From: So Kim
Sent time: 02/20/2019 09:55:54 AM
To: Selim <Selim@sawayaeng.com>
Cc: Ara Mihranian; Jill Martin <jmartin@trumpnational.com>; Rehm, Zach@Coastal <Zach.Rehm@coastal.ca.gov>
Subject: RE: Tract 50666 Fencing plan

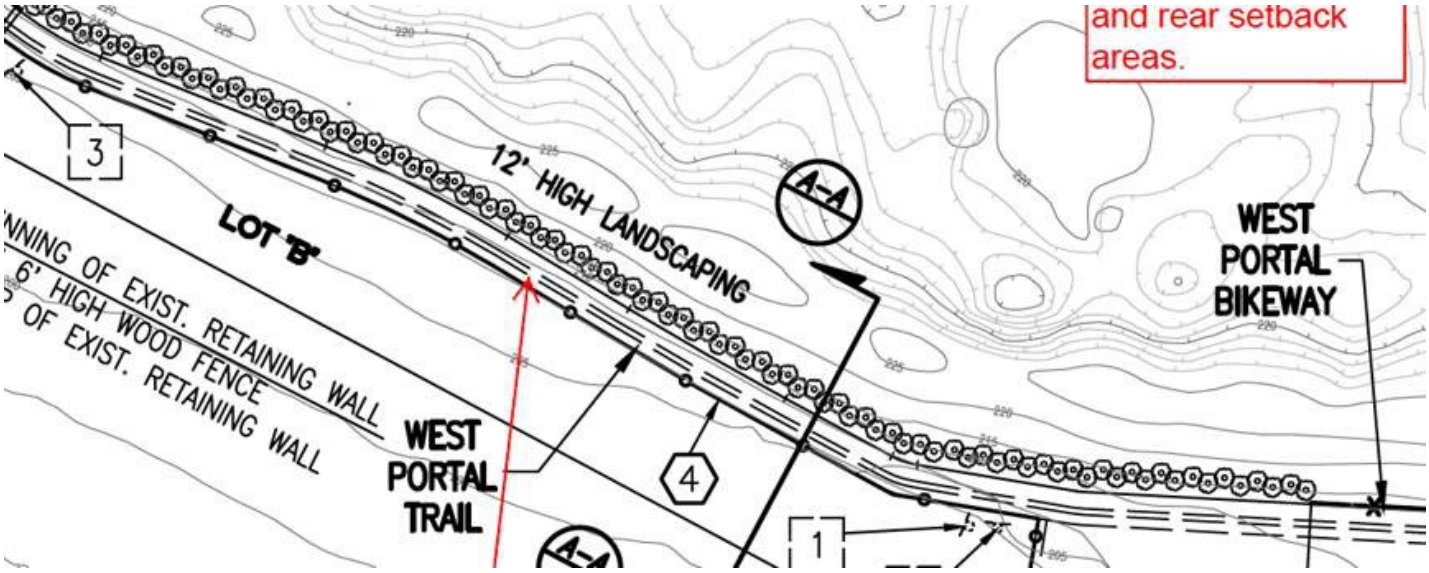
1) Change the notation "12' HIGH LANDSCAPING" to "LANDSCAPING NOT TO EXCEED 12' IN HEIGHT OR THE RIDGE ELEVATION OF THE SOUTHERLY BERM". Based on your map, it appears that the ridge elevation of southerly berm would be 225.

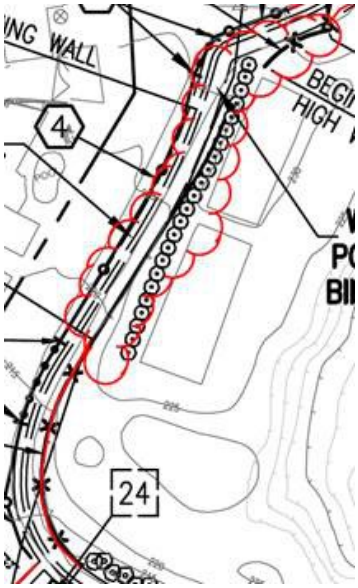
2) Based on Mitigation Measure H-1 above, remove the 6' tall fence located in the bubbled area since there is already a hedge there and begin the fence from the south end of the west hedge to the west end of the south hedge as shown in the solid red line below.
